ALERT SERVICE BULLETIN

NO. 430-99-12

MODEL AFFECTED: 430

SUBJECT: TAIL ROTOR PITCH CHANGE BEARINGS P/N 222-312-753-103, INSPECTION OF; AND TAIL ROTOR BLADE ATTACHING HARDWARE, REPLACEMENT OF

FIGURE 1

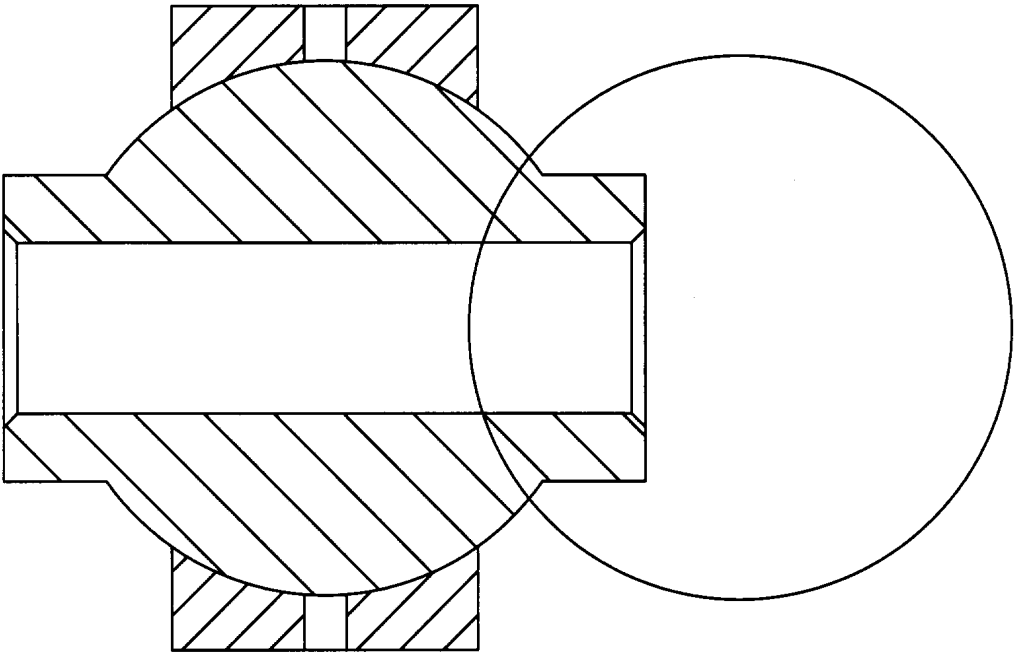
3. Visually inspect each bearing inner member neck area (full 360 degrees) for cracks. Refer to figure 1. If crack(s) are found in a bearing, the replacement of both bearings in that blade are required. Refer to BHT-430-CR&O-3.

INSPECT THIS AREA
BOTH ENDS OF BEARING

BEARING
222-312-753-103
